# ADDENDUM #1

## KEARNEY PUBLIC SCHOOLS NEW KEARNEY HIGH SCHOOL - FOUNDATION PACKAGE KEARNEY, NEBRASKA 1355-F

Wilkins Hinrichs Stober Architects, L.L.C.  
2908 West 39<sup>th</sup> Street, Suite A  
Kearney, Nebraska 68845  
308-237-5787

Date Issued: September 12, 2014

Attachment No. S1.3-3  
 to Addendum No. 1  
 Dated: September 12, 2014

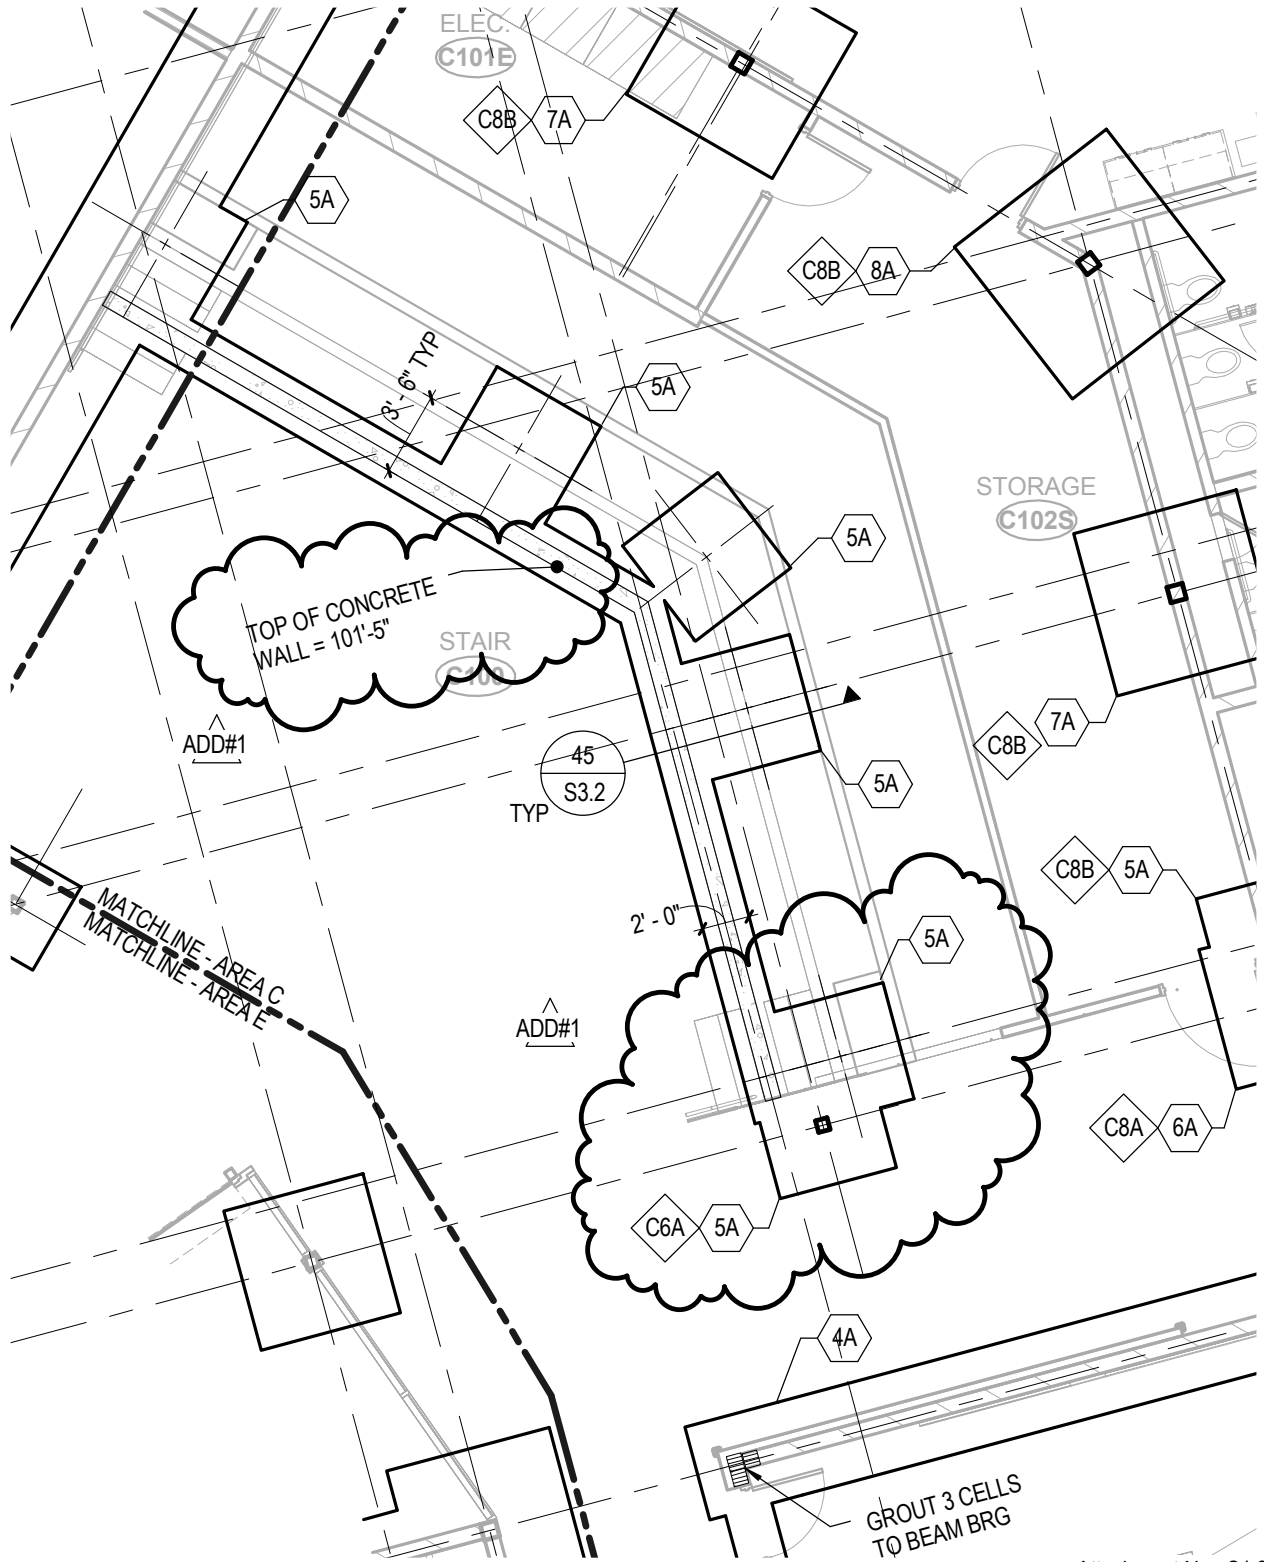
- b. Modify drawing as shown on Attachment S1.3-2 to Addendum No. 1, dated September 12, 2014. Drawing modified to add spread footing.
  - c. Modify drawing as shown on Attachment S1.3-3 to Addendum No. 1, dated September 12, 2014. Drawing modified to shift spread footing.

Attachment No. S1.5-1  
 to Addendum No. 1  
 Dated: September 12, 2014

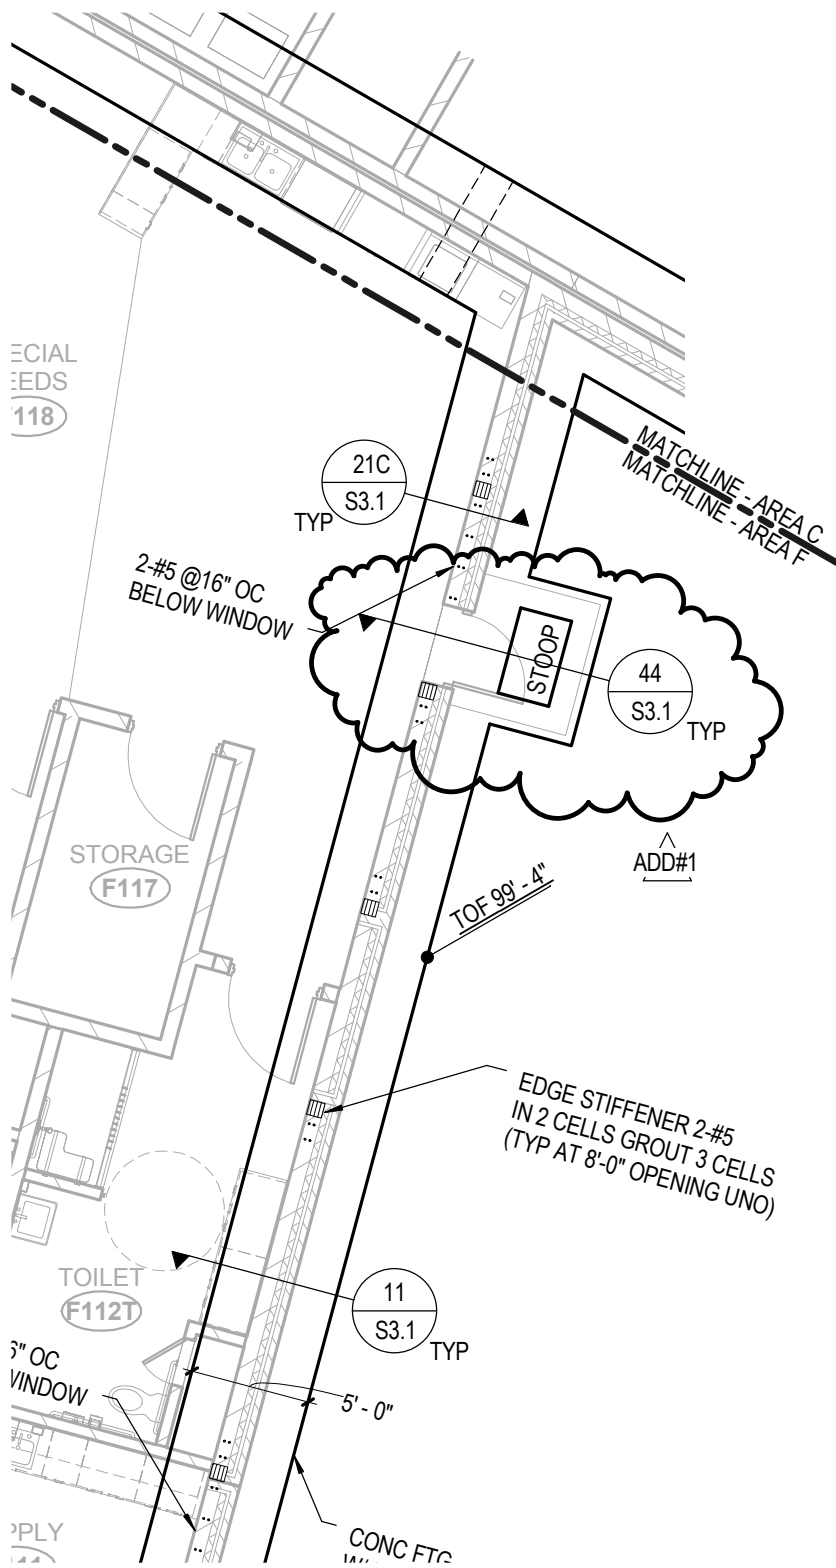
- Addendum #1 - #20 SHEET S1.5 – FOUNDATION PLAN – AREAS E & F**  
 Foundation Plan – Area F - Modify Drawing as shown on Attachment S1.5-1 to Addendum No. 1, dated September 12, 2014. Drawing modified to add stoop.

Attachment No. S1.6-1  
 to Addendum No. 1  
 Dated: September 12, 2014

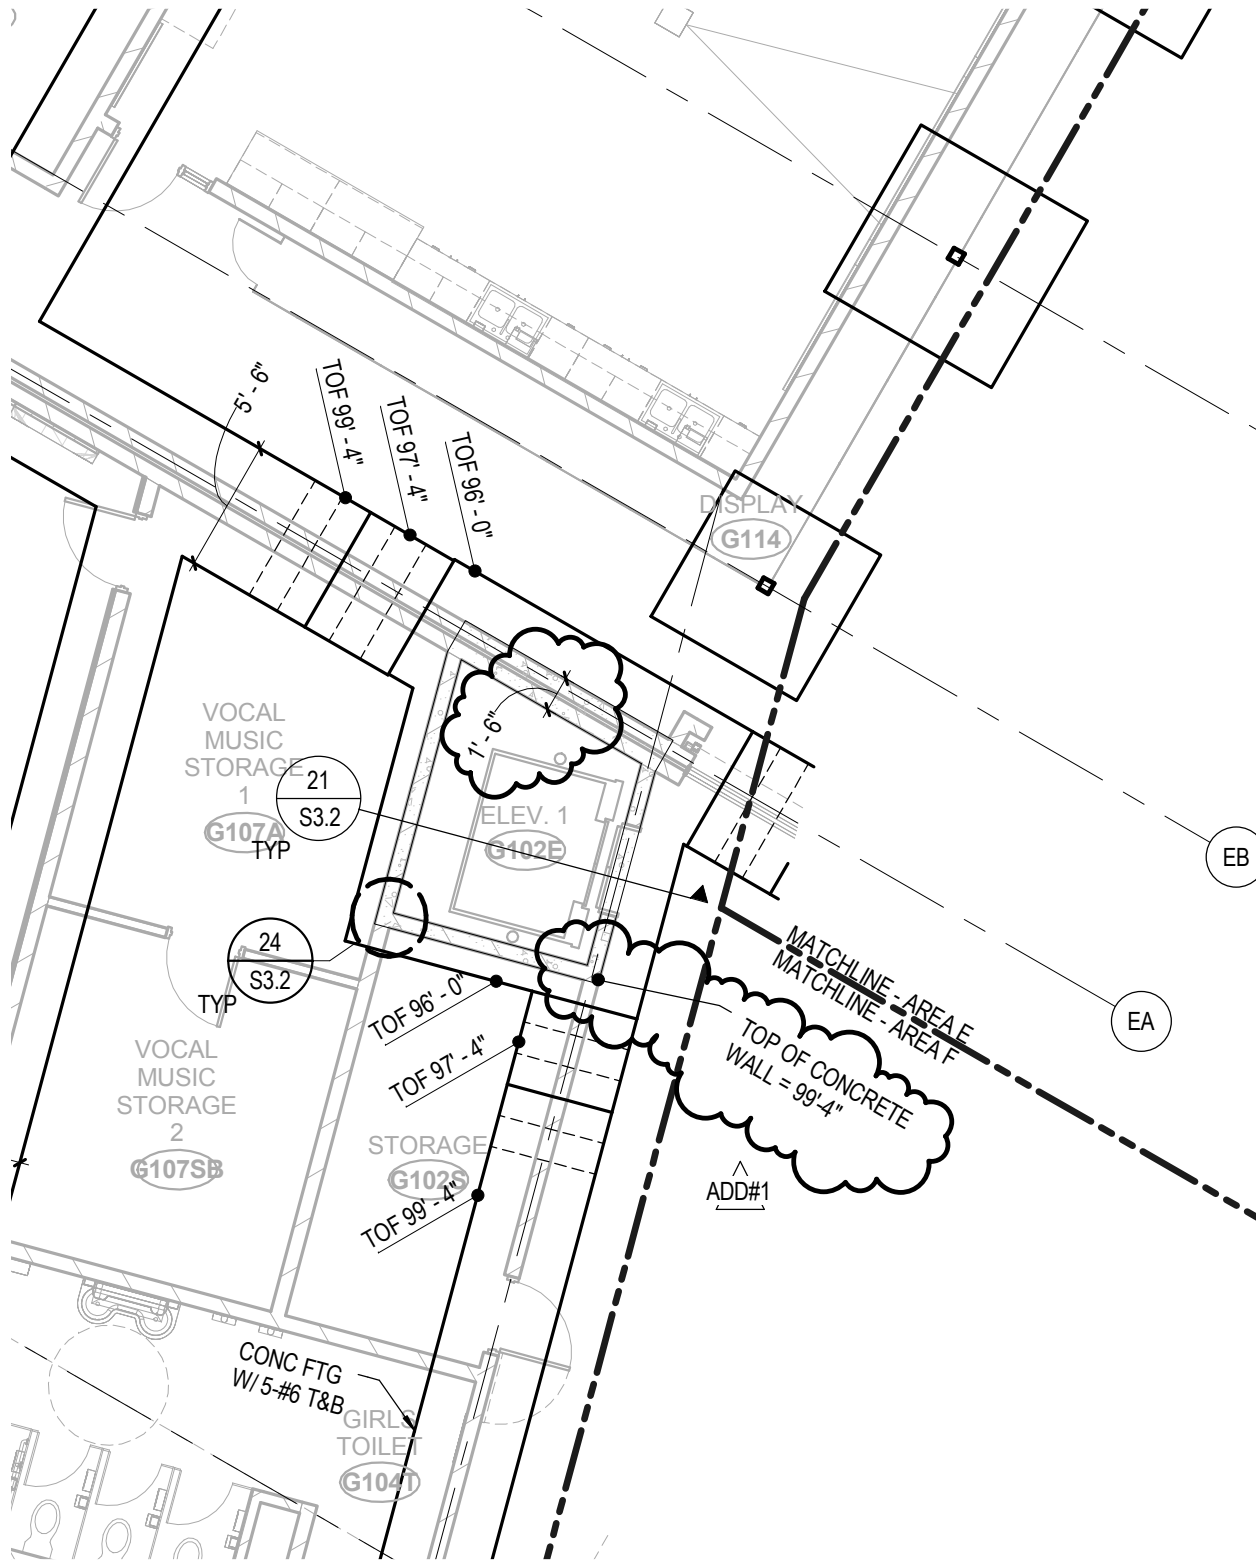
- Addendum #1 - #21 SHEET S1.6 – FOUNDATION PLAN – AREA G**  
 Modify Drawing as shown on Attachment S1.6-1 to Addendum No. 1, dated September 12, 2014. Drawing modified to clarify elevator pit wall extent.
